ADDENDUM NO. 1,

Muck Creek Mitigation Bid No. 25-C3136

May 1, 2025
9 Pages including 2 cover sheets.

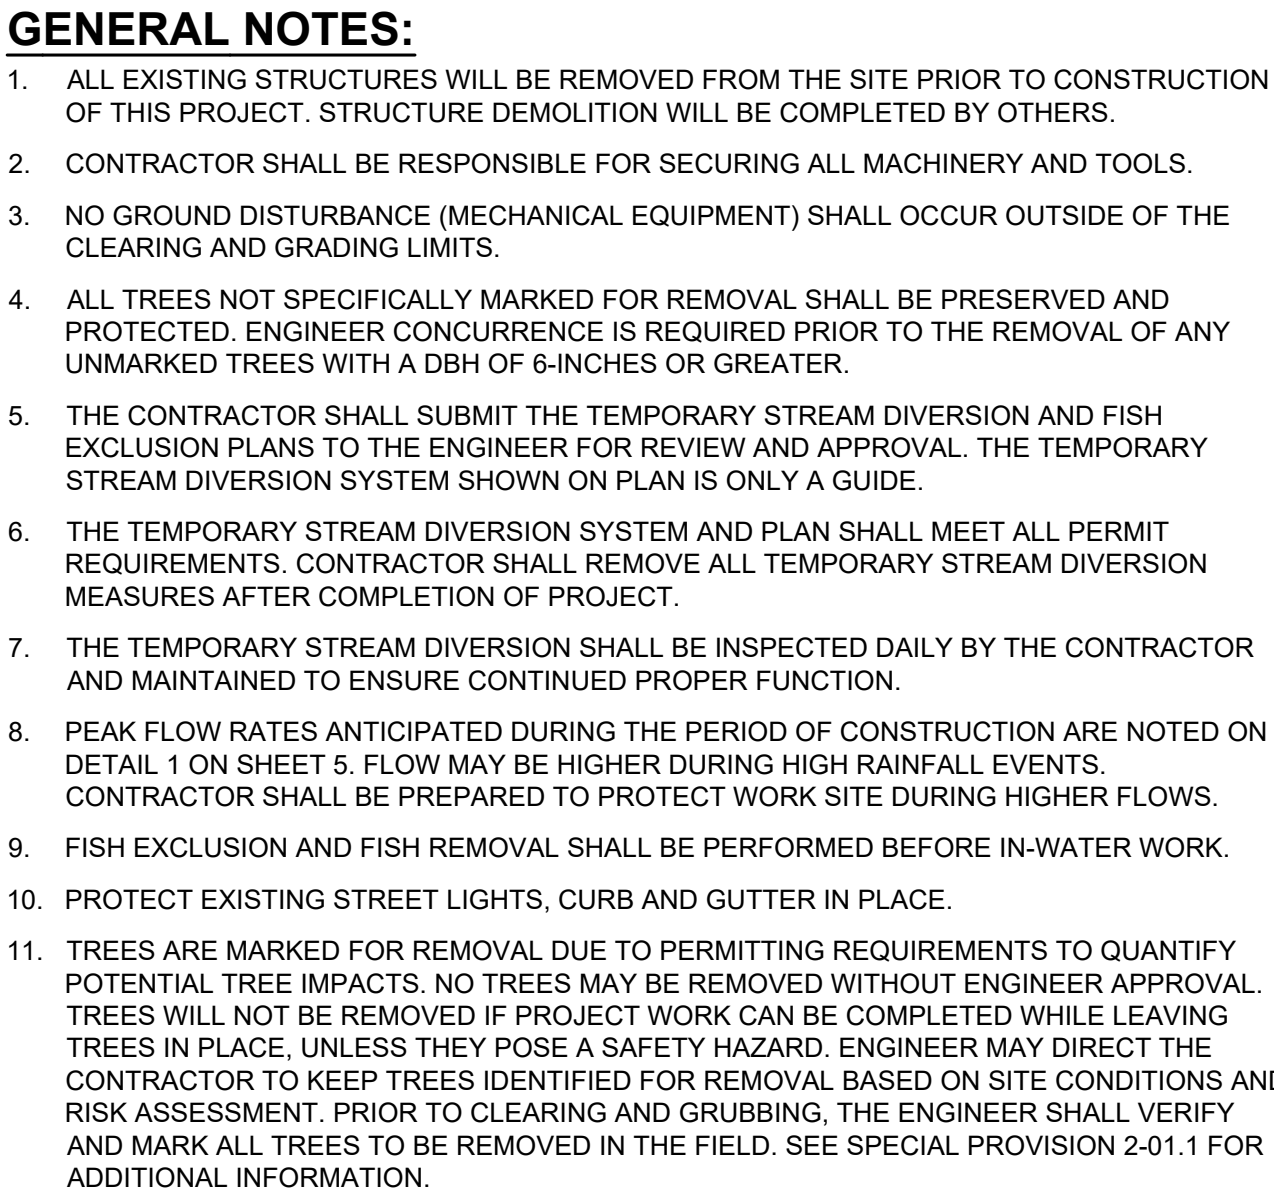
3. Contract Plans (3 pages total):
 - a. Site Preparation, Stream Diversion, & TESC Plan (Sheet 4) – Updated General Note #11 to clarify tree removal requirements. (1 page)

FILTER BAG
	RIPRAP MAT
	PUMP
	TURBIDITY MONITORING STATION
	GRAVEL BAG
	FISH SCREEN
	REMOVE TREE (SEE NOTE 11)

MUCK CREEK MITIGATION
18727 73RD AVE NE
STREAM PLAN

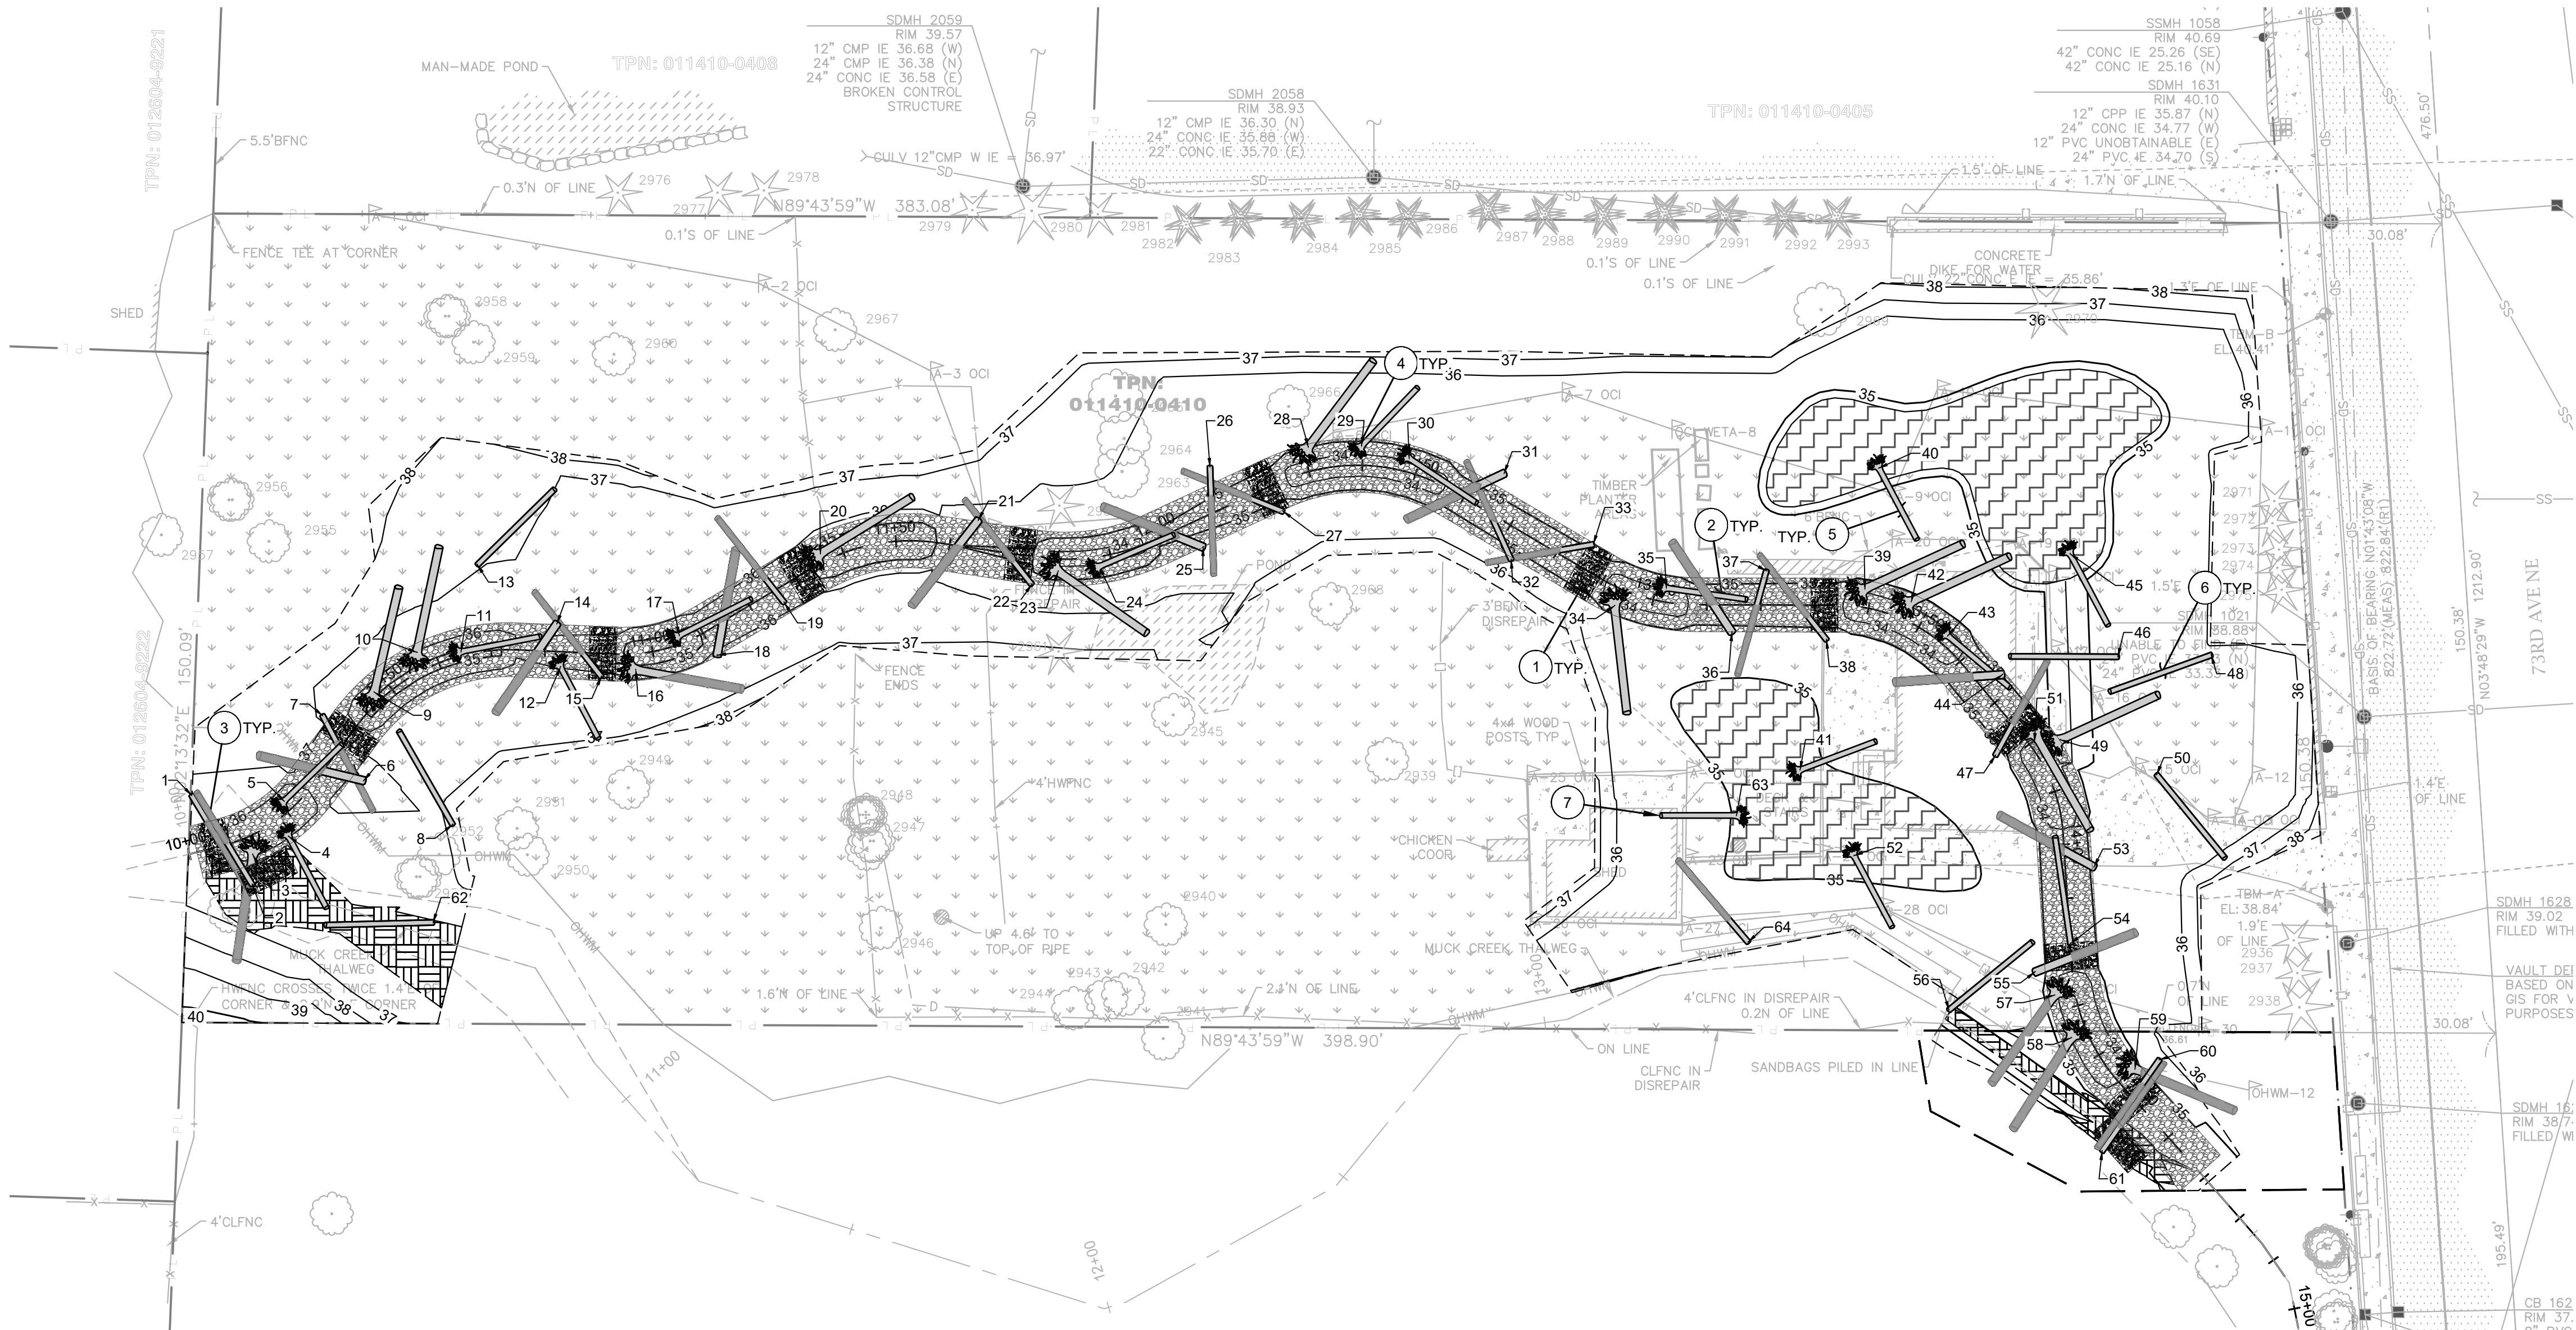
- b. Stream Plan (Sheet 7) – Revised approximate location and orientation of 10 log pieces such that they are installed more fully within the low-flow channel and oriented close to parallel with the stream alignment. (1 page)

- SEE SHEET 6 AND SHEET 8 FOR PROPOSED GRADING PLAN AND PROFILE.
- SEE SECTIONS A, B AND C ON SHEET 8 FOR TYPICAL CROSS SECTIONS.
- ALL DISTURBED AREAS SHALL BE RESTORED PER THE PLANTING PLAN ON SHEET 10.
- LOCATIONS AND ORIENTATIONS OF LOG PIECES AS SHOWN ON THIS SHEET ARE APPROXIMATE. LOG INSTALLATION WILL BE DIRECTED IN THE FIELD BY THE ENGINEER. SEE SPECIAL PROVISIONS SECTION 8-34.
